## **NTS Objection to Berwick Bank Offshore Windfarm**

### **1. Summary**

Fig 1. St Abb's Head NNR property boundary and SPA boundary

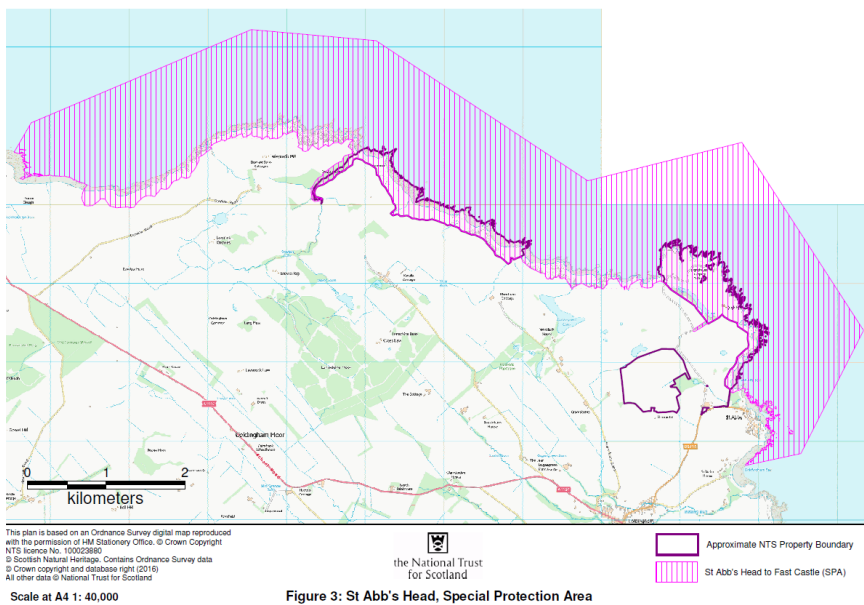
St Abb's Head NNR has internationally important seabird colonies. The cliffs are populated by about 45,000 seabirds during the breeding season which includes internationally important numbers of guillemots (approximately 3% of the British breeding population) and nationally important numbers of kittiwakes, razorbills and shags. Due to this St Abb's Head is a popular birdwatching site. Our seabird population monitoring means we hold a dataset spanning more than 30 years. This dataset is of significant value as very few other sites in the UK have such a long time series.
